Tuesday, May 17, 2022

McFarland Municipal Center
Community Room

AGENDA

4721 FARWELL STREET DEVELOPMENT
PROPOSED SITE PLAN
SHEET: C-2
DATED: APRIL 5, 2022

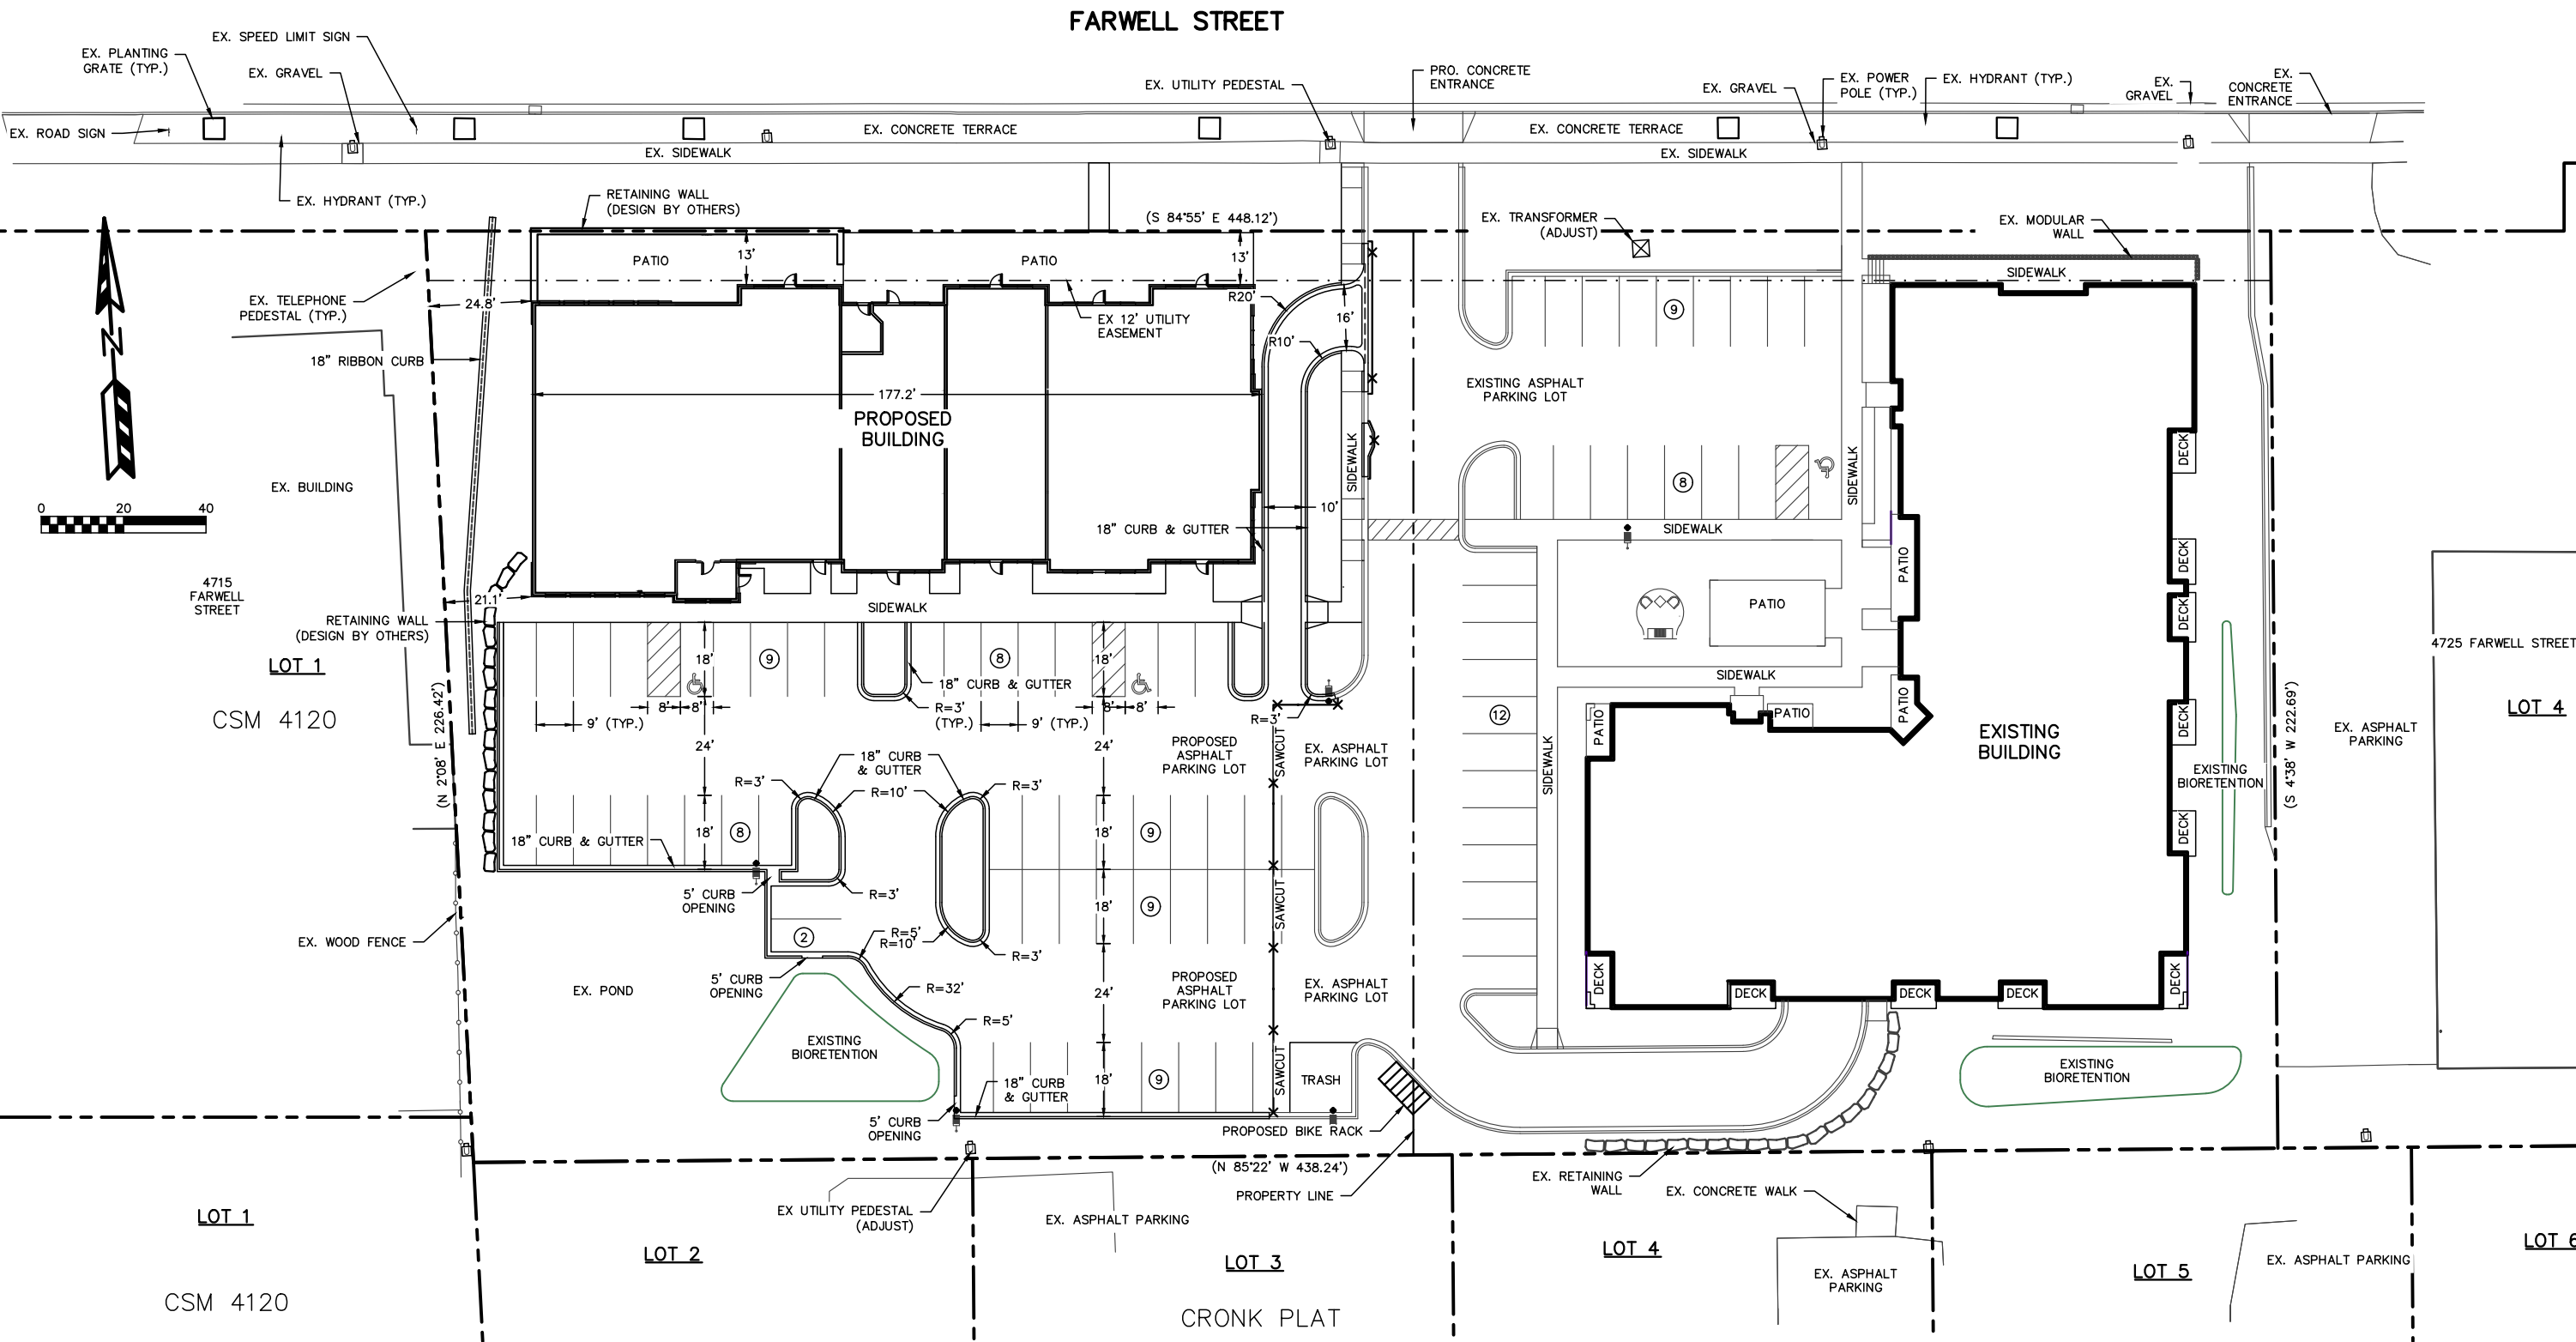
Our review of the Proposed Site Plan, Sheet C-2 yielded concerns with the fire department apparatus access in the extension of the parking lot south of the proposed new building. The International Fire Code (IFC) Appendix D requires a 28' turning radius with a width of 20' for access roads. The parking lot is not required to maintain the access due to the access from Farwell Street to the building. However, the design is close to meeting the requirement. We believe with minor adjustments the parking lot would comply. A parking lot that is close to complying may cause issues in the future with fire apparatus operators assuming the parking lot complies with the IFC and it doesn't. It would be preferred to make the adjustments to avoid future issues.

4721 FARWELL STREET DEVELOPMENT
GRADING & EROSION CONTROL PLAN
SHEET: C-3
DATED: APRIL 5, 2022
QUAM ENGINEERING, LLC
Residential and Commercial Site Design Consultants
www.quamengineering.com
4604 Siggelkow Road, Suite A - McFarland, Wisconsin 53558
Phone (608) 838-7750; Fax (608) 838-7752

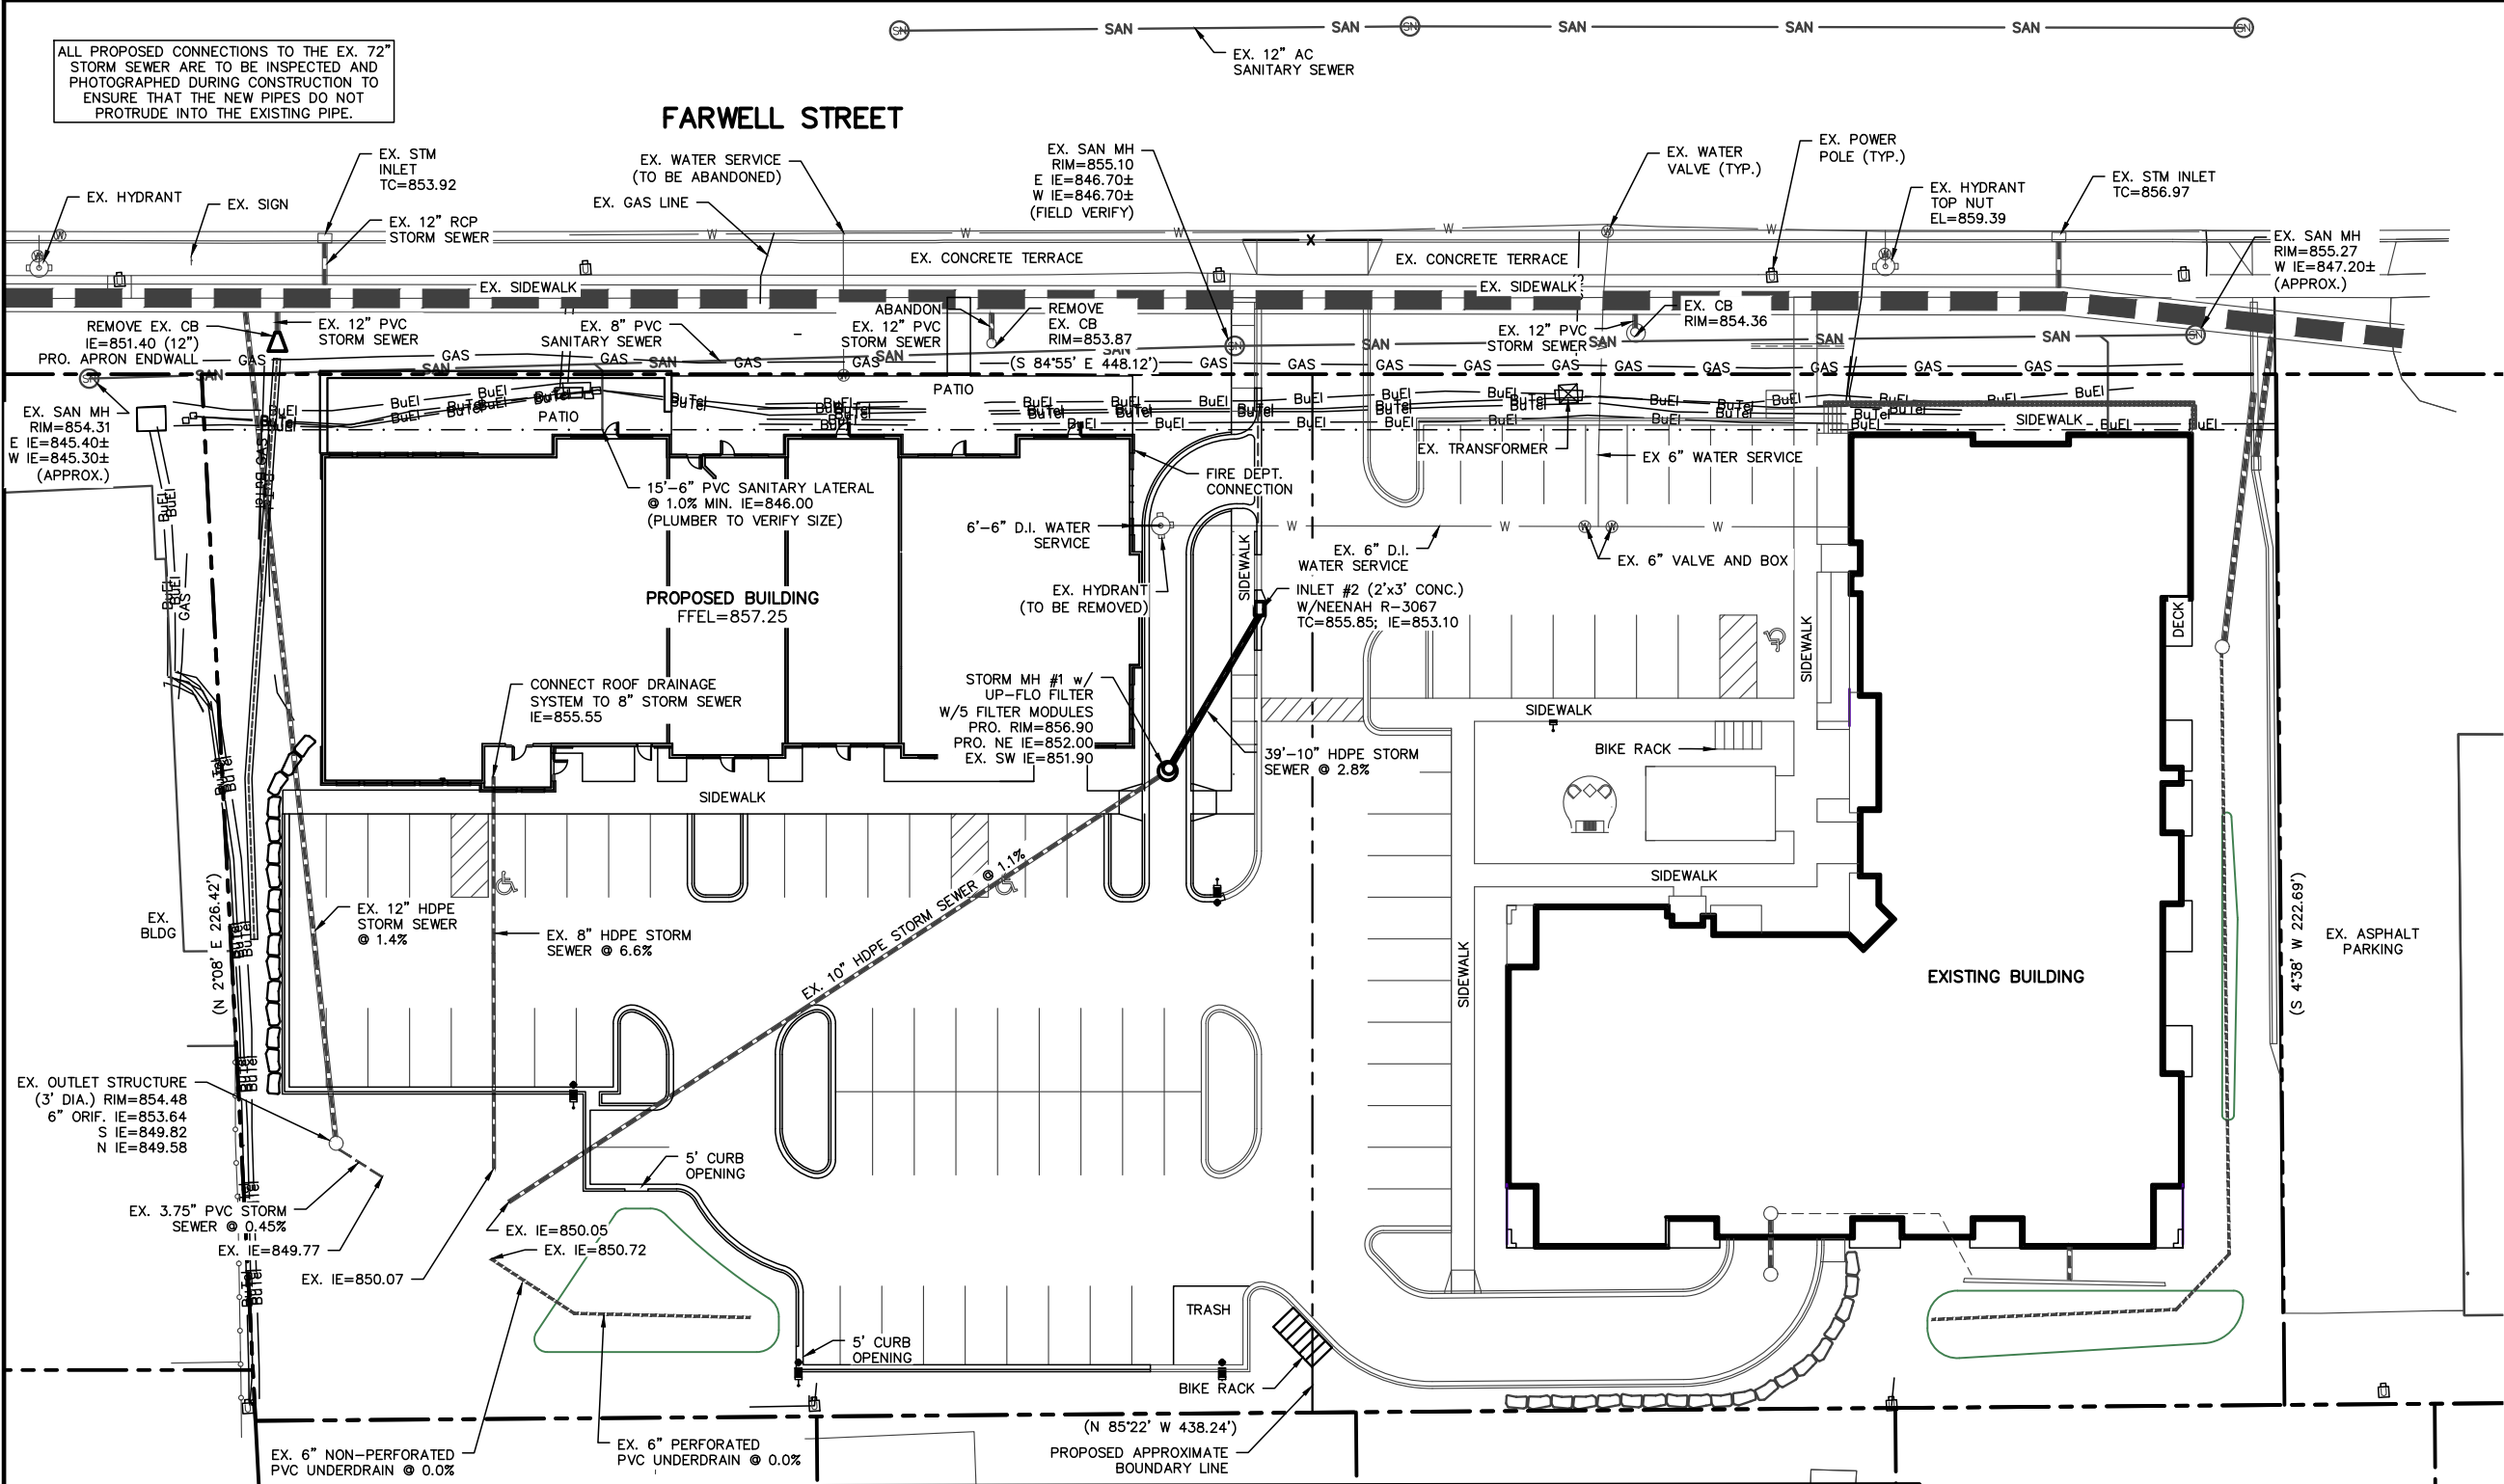
1. Sheet C-3 – The proposed building now has a patio that with a retaining wall shown along the right-of-way line (the original plans showed an at grade patio). We recommend the retaining wall be placed 1-3 feet away from the right-of-way to both facilitate future wall replacement and Village use of the full right-of-way area.

SHEET: C-4
DATED: APRIL 5, 2022

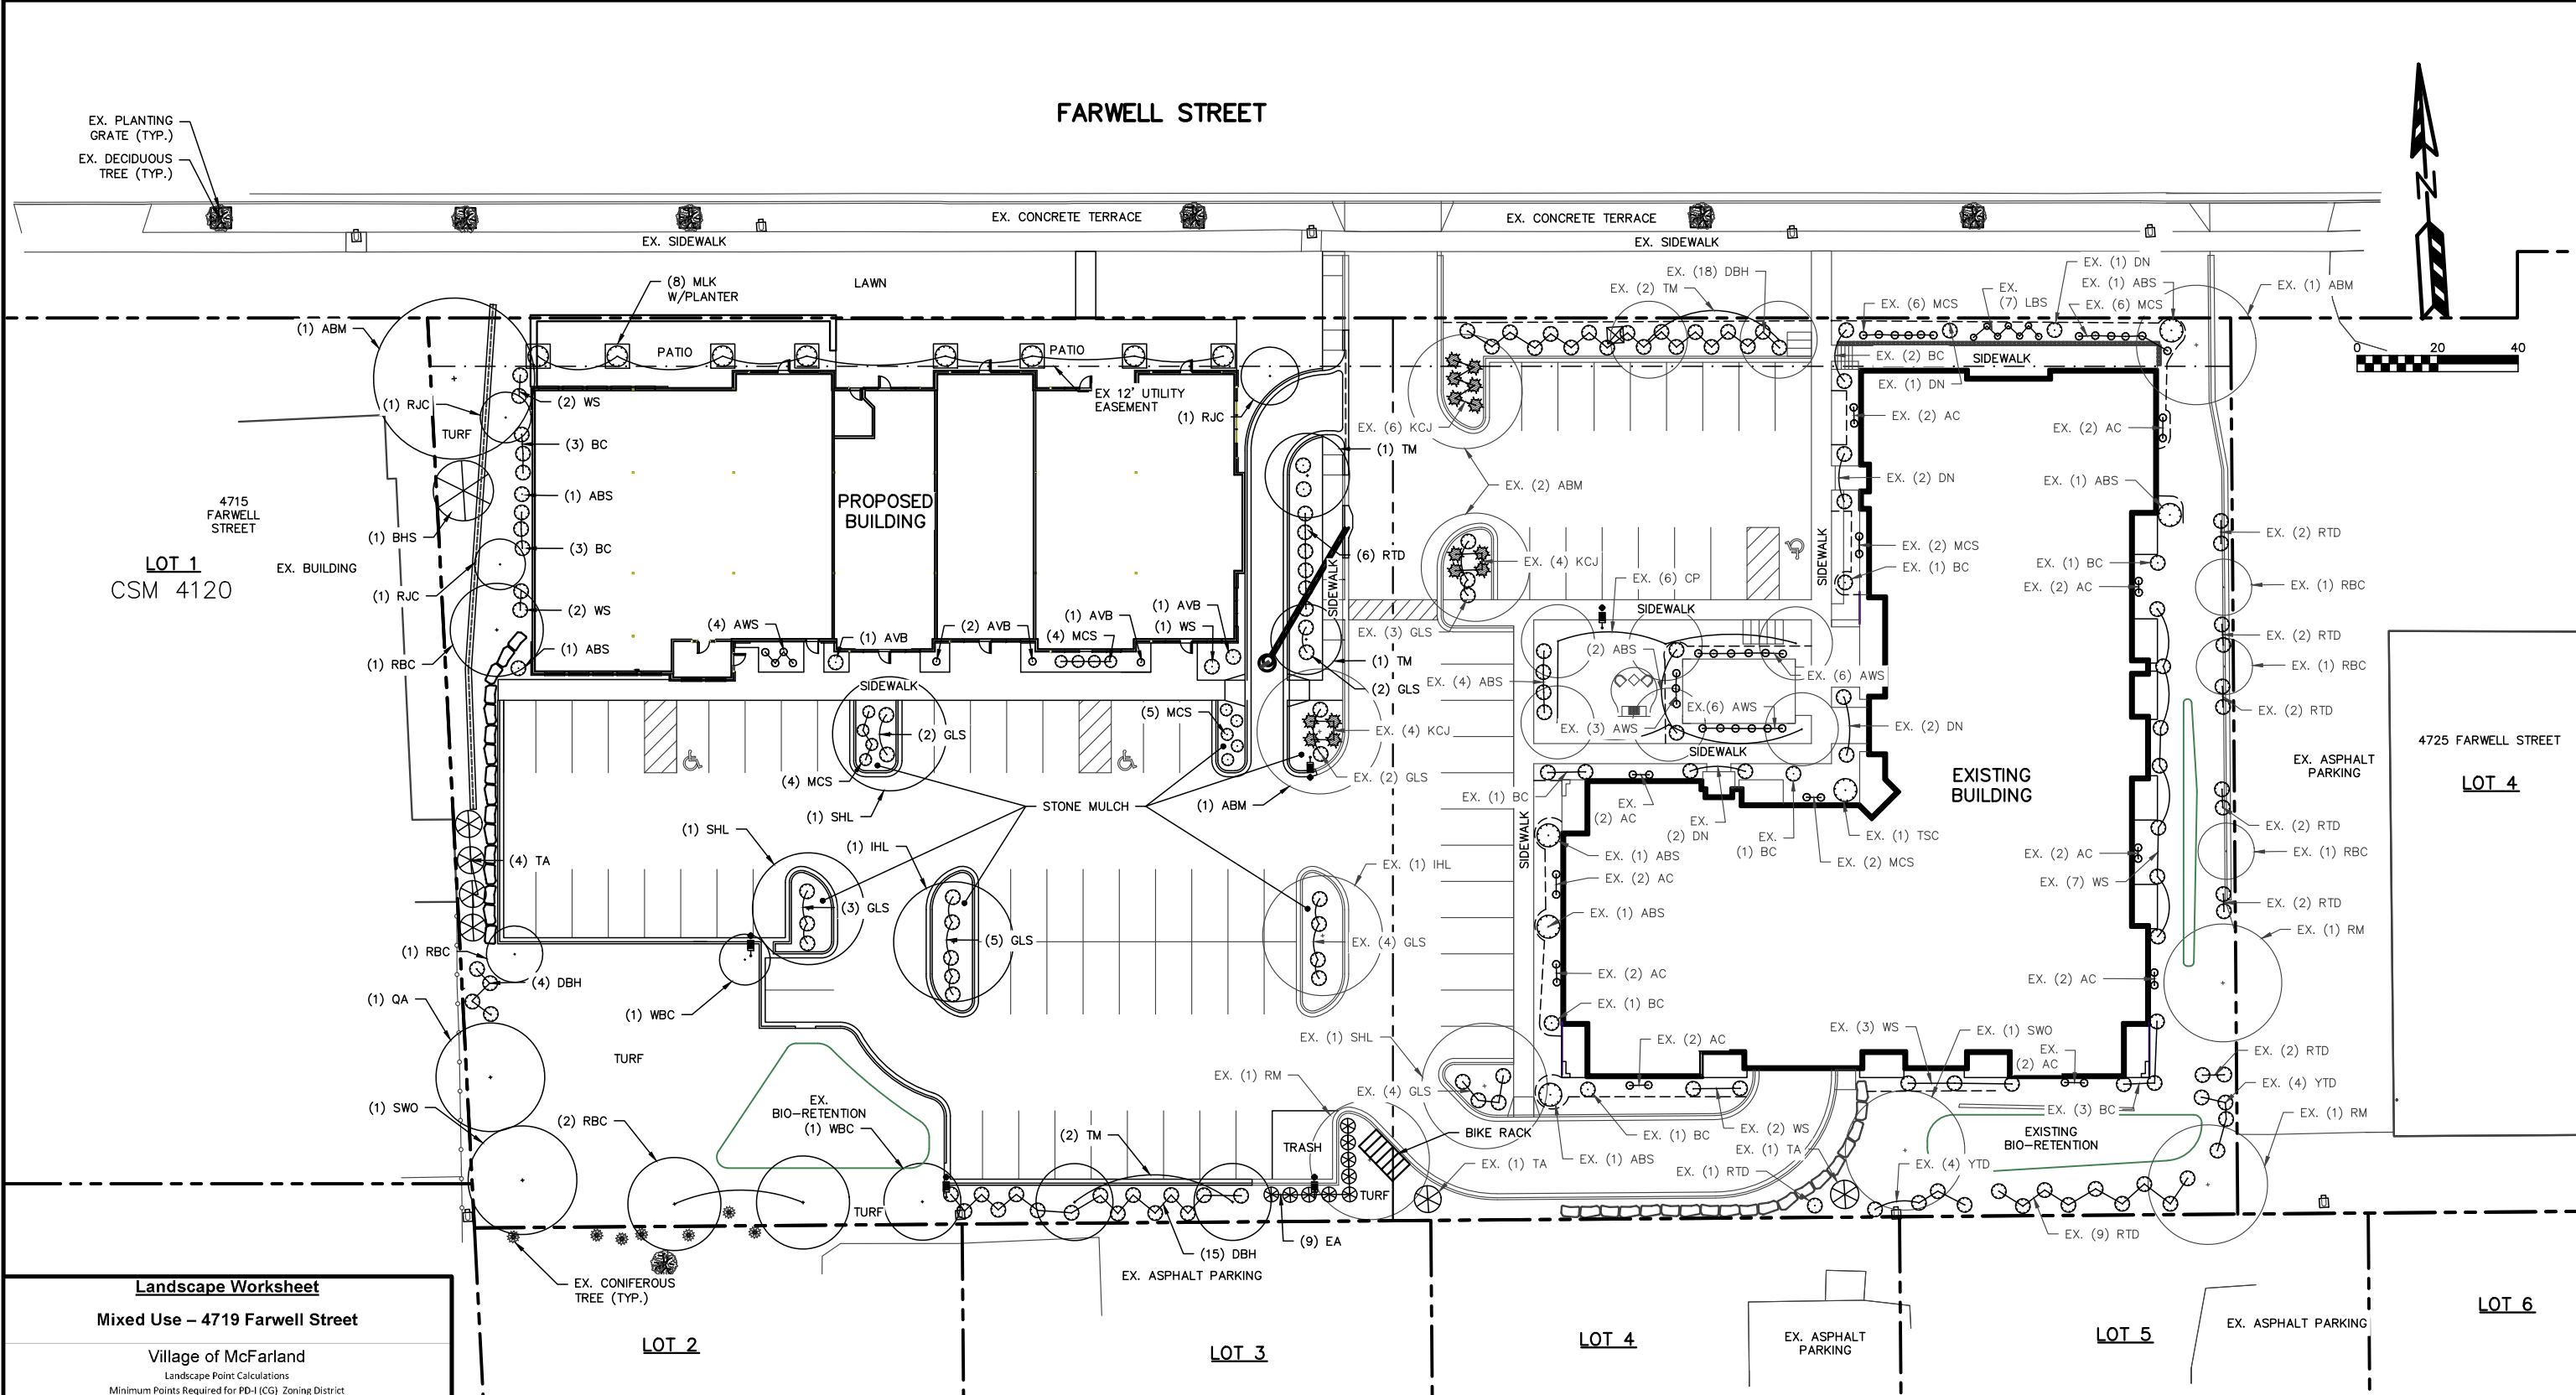
2. Sheet C-4 shows the utility work to be done. The new building will be served by an existing sanitary sewer lateral and will receive water service off the end of the temporary hydrant that was placed in Phase 1. These connections are acceptable.
